FIRE PROTECTION
SAFETY EVALUATION REPORT
BY THE
OFFICE OF NUCLEAR REACTOR REGULATION
U.S. NUCLEAR REGULATORY COMMISSION
IN THE MATTER OF
DAIRYLAND POWER COOPERATIVE
LACROSSE BOILING WATER REACTOR
DOCKET NO. 50-409

Date: July 27, 1979

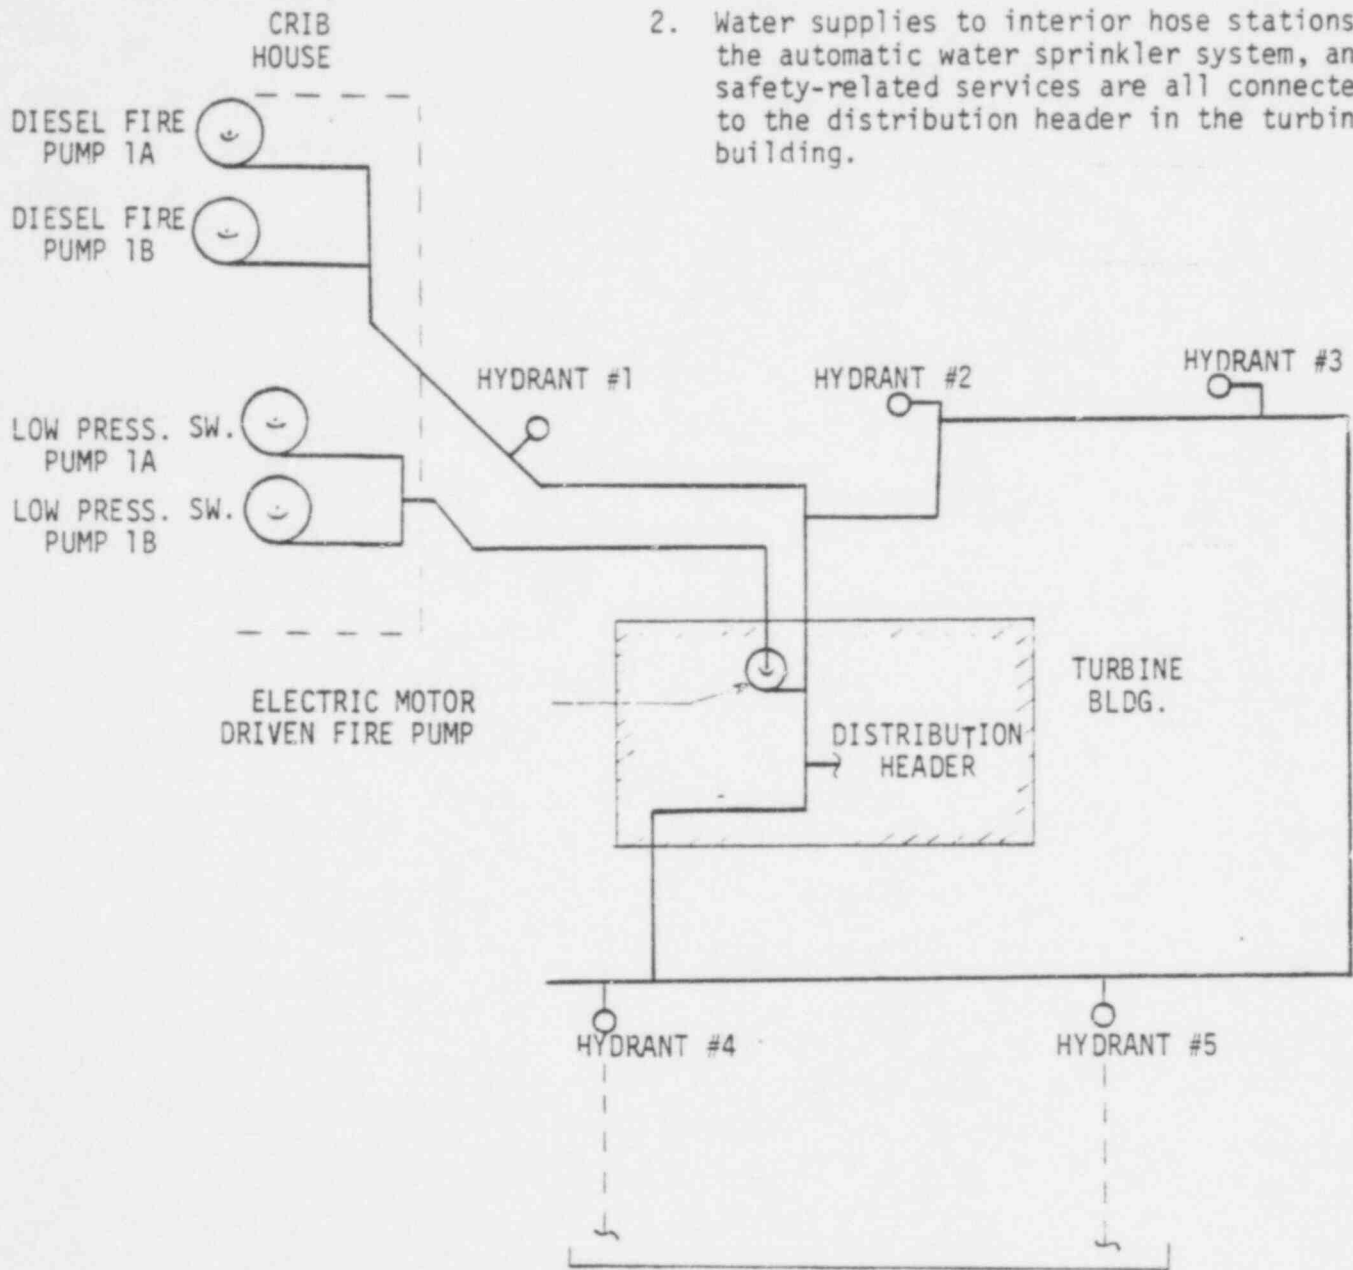
The fire protection water system is also the high pressure service water system (HPSW). In addition to supplying water for fire protection, the HPSW system supplies water for safety-related and nonsafety-related services as identified in Section 4.3.1.3. The schematic of the fire water piping system is shown in Figure 4.3.1.

The water supply is developed by two diesel driven vertical shaft centrifugal fire pumps, each with a rated output of 750 gpm at 125 psig, and a motor
